**King's Mark  
Environmental  
Review  
Team  
Report**

**Fawn Woods  
Subdivision

Roxbury,  
Connecticut**

Prepared by the King's Mark Environmental Review Team  
of the King's Mark Resource Conservation  
and Development Area, Inc.

**PROPOSED  
SITE PLAN**

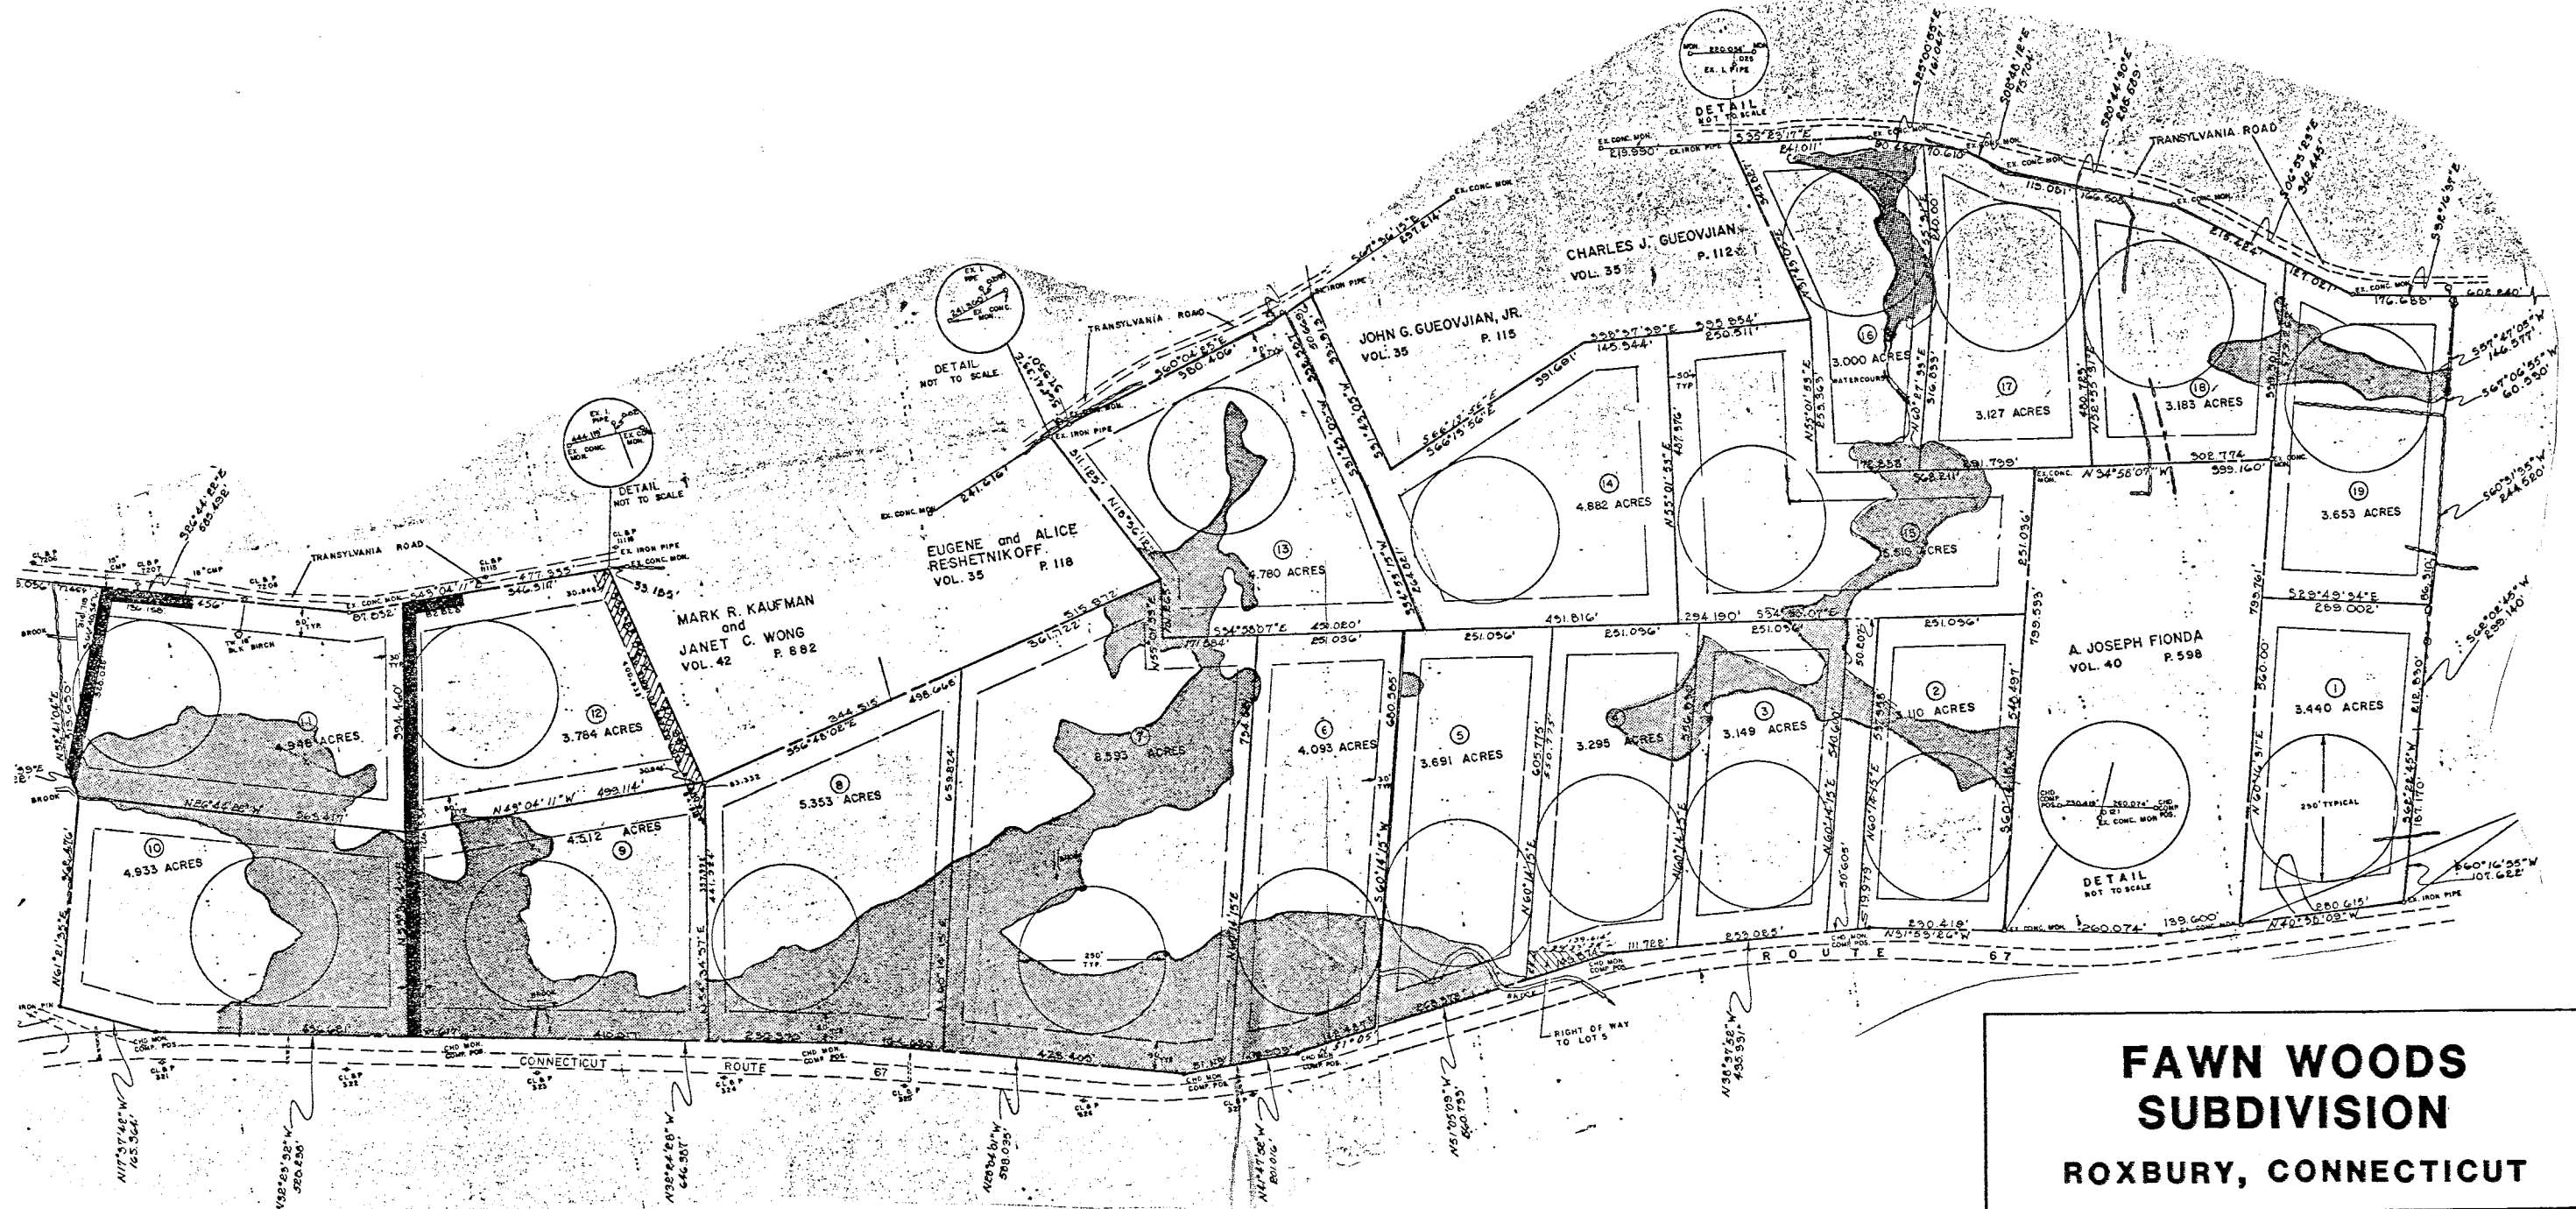
- (1) The house and septic system for Lot 15 appear to be in a depression and may receive surface and subsurface water from upslope. Deep test pits at a wetter time of year may reveal a seasonal wetness limitation for on-site sewage disposal.
- (2) Because of soil limitations and grades, a considerable amount of fill would be needed across wetlands on Lots 5, 6, 7, 8, 9, and 10. Fill and crossings should be minimized or eliminated.
- (3) Additional deep test pits may be needed for Lots 8 and 14 to locate suitable soils because of the variable depth to bedrock.

Placement of driveways is also critical. For example, the driveway for Lot 5 should not be routed straight up the hill. Presently part of this driveway would have a grade of 20 percent or more with this particular route.

Proper lot planning will avoid drainage and erosion problems for Lots 11, 12, 16, and 17. These lots have intermittent drainageways not shown on the subdivision plan. House sites and septic fields should not be located within these drainageways. These lots have adequate space for building in better drained areas. Driveway crossings should have culverts to allow free passage of runoff water.

Five proposed driveway crossings of the unnamed brook and the lower wetlands running parallel to Route 67 were considered a concern because of potential negative impacts on water quality and wetland integrity. The crossings are proposed for Lots 5, 6, 7, 8, and 9. Lots 6 and 7 and Lots 8 and 9 have their driveways adjacent to one another, separated by the property line (see Figure 2). By town regulations, the minimum driveway width is 12 feet. Crossing the wetlands and brook for these driveways will require extensive fill. For example, two adjacent driveways will have a top width of 24 feet. For stability, the fill should be graded with a minimum of 2:1 sideslopes. Using a figure of eight feet of fill, the base of the sideslopes would extend 16 feet from each top edge of fill. Therefore, the total base width would be approximately 56 feet (i.e.,  $24 + 16 + 16 = 56$ ). This figure can be applied to two adjacent driveways crossings. The single driveway crossing would have a base of approximately 44 feet.

Alternative means of accessing Lots 5, 6, 7, 8, and 9 are possible. Lot 5 could be accessed from below the brook crossing of Route 67 via a right-of-way on Lot 4. This would eliminate one driveway crossing of the wetland.

Another alternative is the construction of a new road off Transylvania Road for access to these lots. One possible route for this road is from Lot 18, passing through lots 17, 15, 14, 13, 7, 8, 9, 12 to Lot 11. This route can follow the level in some areas, but in other areas grades will require careful route layout. Some wetlands on Lot 7 would be crossed by this alternative route. Though a new road would cause some environmental impact, increase the potential for stormwater runoff, and require a significant capital outlay, the culmulative impacts on the unnamed brook and all existing wetlands would be lessened considerably, and curbs cuts entering Route 67 would be substantially reduced.

A third alternative is accessing Lots 8 and 9 with a driveway from Transylvania Road via a right-of-way on Lot 12. Direct access from Lot 12 may be impractical due to the steep grades (i.e., 30 percent) in portions of this lot. Accessing Lot 11 may be possible if the driveway cuts diagonally through this lot.

If the first and third alternatives are used, only two adjacent driveway crossings of the lower wetland and brook will occur (Lots 6 and 7). If the second alternative is used, the lower wetland and brook will not be crossed by any driveways. Access to these lots would be provided from the proposed road.

# WATERSHED BOUNDARY

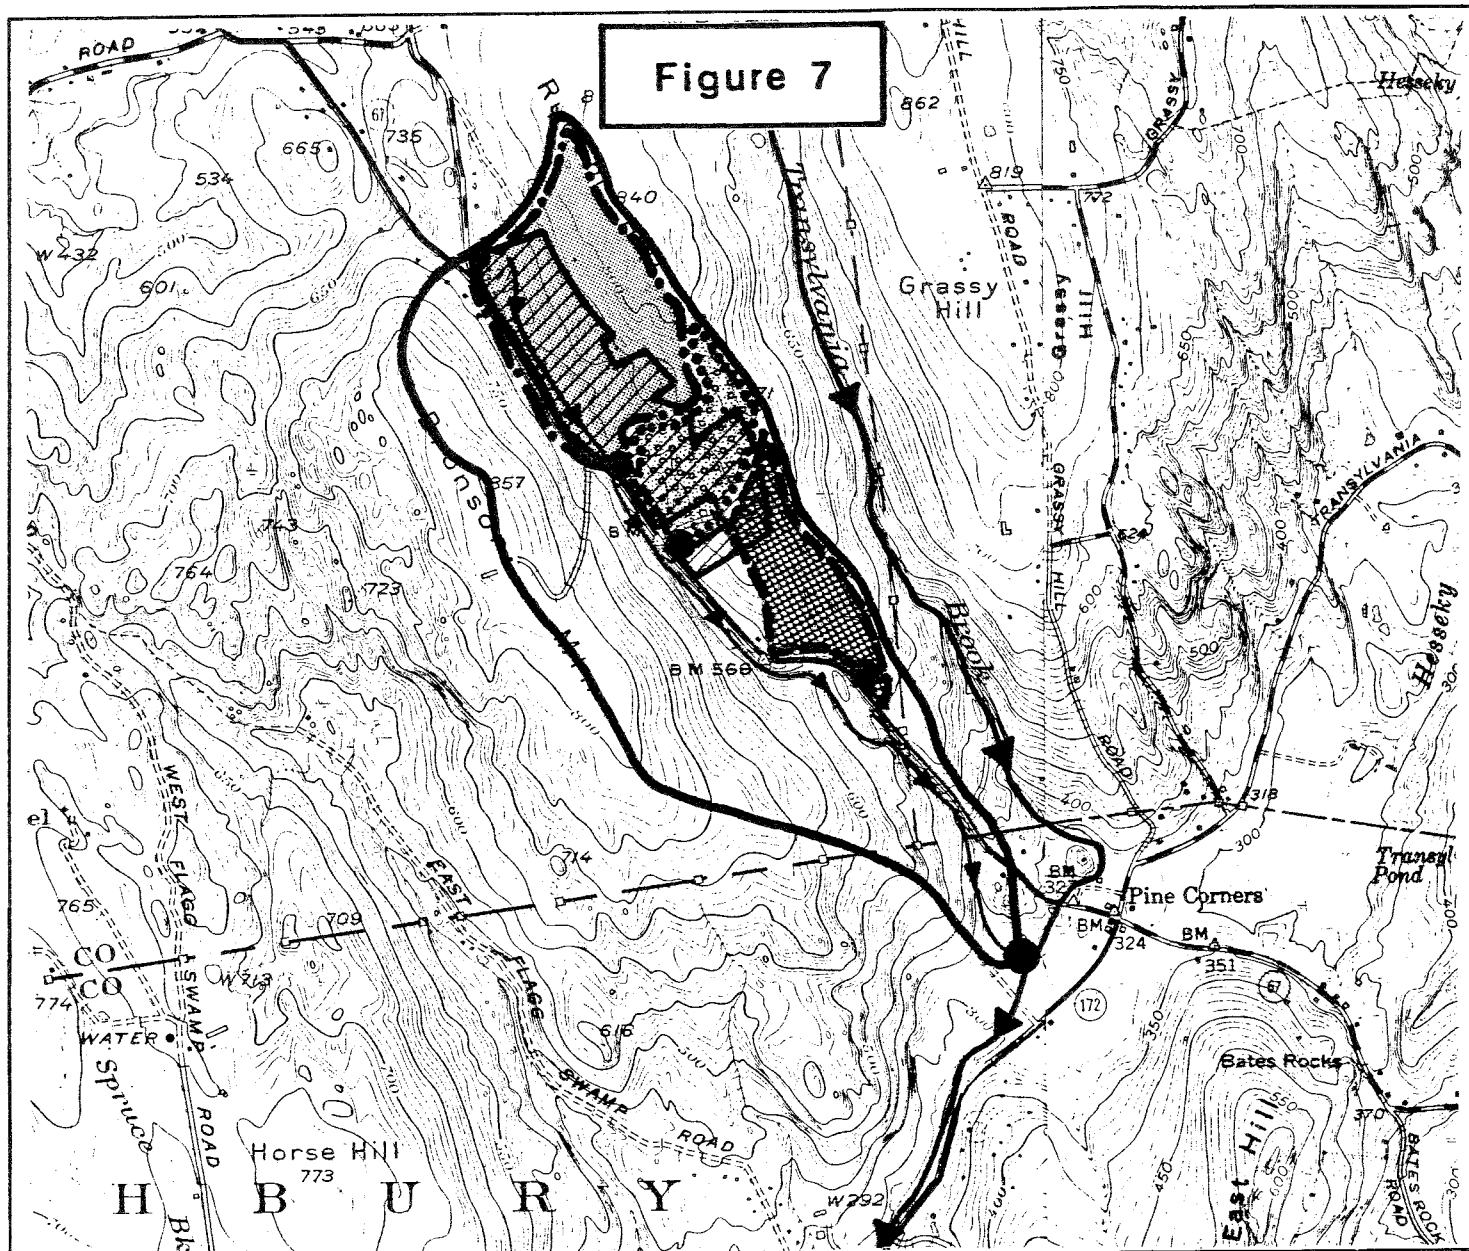
As such, over 50 percent or 10 of the proposed lots, drain to a 2-foot by 5-foot boxarch-type culvert passing under Route 67 in front of Lot 4. Four lots along Transylvania Road (i.e., 16 to 19) will drain to a deep drainageway on Lot 19 and ultimately joins the unnamed brook in the watershed about 2,600 feet downstream. The remaining five lots will flow to the drainageway that passes under a private driveway (Fionda property, see Figure 2) and which ultimately passes under Route 67 and Transylvania Road.

The wetlands along Route 67, to which the highest percentage of lots (about 50 percent) will drain, is in an ideal location to serve as a natural runoff control basin, particularly since it is in the upper part of the watershed. This will allow runoff arising from the upper third of the watershed to be temporarily detained during the remainder of the watershed, where there is little opportunity for natural detention to drain quickly. Runoff stored in the wetlands will begin to drain once the unnamed brook has crested, thereby lessening the effects of flooding downstream. Finally, as a matter of policy, the applicant's engineer should supply the Town with a stormwater management plan which includes hydrologic calculations. Closer examination of downstream culverts, especially those passing under Route 67 and Fionda's driveway is also warranted.
